# Customer Satisfaction Program

## 17455 Dinghy Towing Causing Tire Squeal

Reference Number: A172119210

### Insert to the 2017 and 2018 Chevrolet Spark Owner's Manual

#### Dinghy Towing (with Manual Transmission)

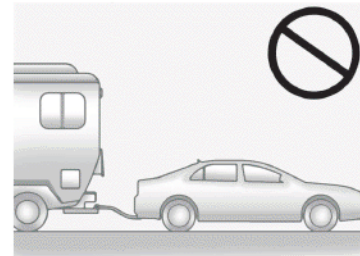
*This information replaces the "Dinghy Towing (with Manual Transmission)" information under "Recreational Vehicle Towing" found in the owner's manual.*

To dinghy tow the vehicle from the front with all four wheels on the ground:

1. Position the vehicle to tow and then secure it to the tow vehicle.
2. Apply the parking brake.
3. Shift the transmission to Neutral.
4. Disconnect the negative battery cable at the battery. See "Negative Battery Cable Disconnection" following.
5. Cover the negative battery post with a non-conductive material to prevent any contact with the negative battery terminal.
6. Release the parking brake.

If 113 km/h (70 mph) is exceeded while towing the vehicle, it could be damaged. Never exceed 113 km/h (70 mph) while towing the vehicle.

#### Negative Battery Cable Disconnection

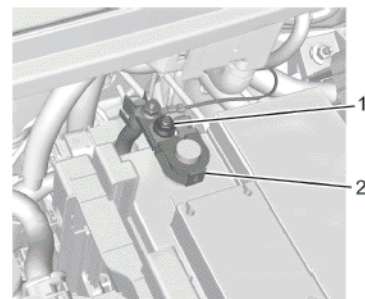
*This information is in addition to the "Battery - North America" information found in the owner's manual.*

1. Make sure the lamps, features, and accessories are turned off.
2. Turn the ignition off and remove the key, if equipped.

3. Loosen the negative battery cable nut (1).
4. Remove the negative battery cable (2) from the battery.

**Remorquage sur quatre roues (avec boîte de vitesses manuelle)**

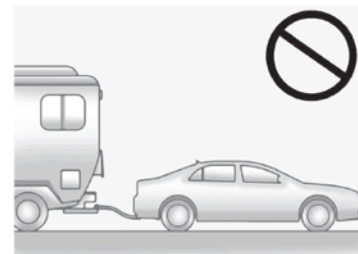
Ces informations remplacent le chapitre « Remorquage sur quatre roues (avec boîte de vitesses manuelle) » sous « Remorquage avec véhicule de loisir » dans le manuel du propriétaire.

Pour effectuer un remorquage pneumatique du véhicule par l'avant avec les quatre roues sur la route :

1. Positionner le véhicule à remorquer, puis le fixer au véhicule remorqueur.
2. Serrer le frein de stationnement.
3. Mettre le levier de vitesses au point mort (N).
4. Débrancher le câble négatif de la batterie au niveau de la batterie. Voir « Débranchement du câble négatif de la batterie » ci-après.
5. Recouvrir la cosse négative de la batterie avec un matériau non-conducteur pour empêcher tout contact avec la borne négative de la batterie.
6. Desserrer le frein de stationnement.

Si vous dépassez 113 km/h (70 mi/h) pendant le remorquage de votre véhicule, il pourrait subir des dégâts. Ne jamais dépasser 113 km/h (70 mi/h) lors du remorquage de votre véhicule.

**Débranchement du câble négatif de la batterie**

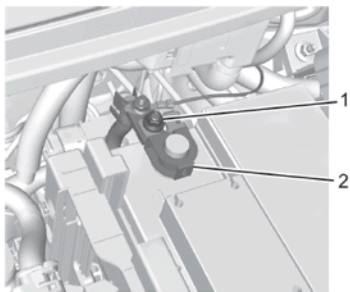
Cette information complète au chapitre « Batterie - Amérique du Nord » dans le manuel du propriétaire.

1. S'assurer que les feux, fonctions et accessoires sont éteints.
2. Couper le contact et retirer la clé, le cas échéant.

3. Desserrer l'écrou de câble négatif de batterie (1).
4. Déposer le câble négatif de batterie (2) de la batterie.
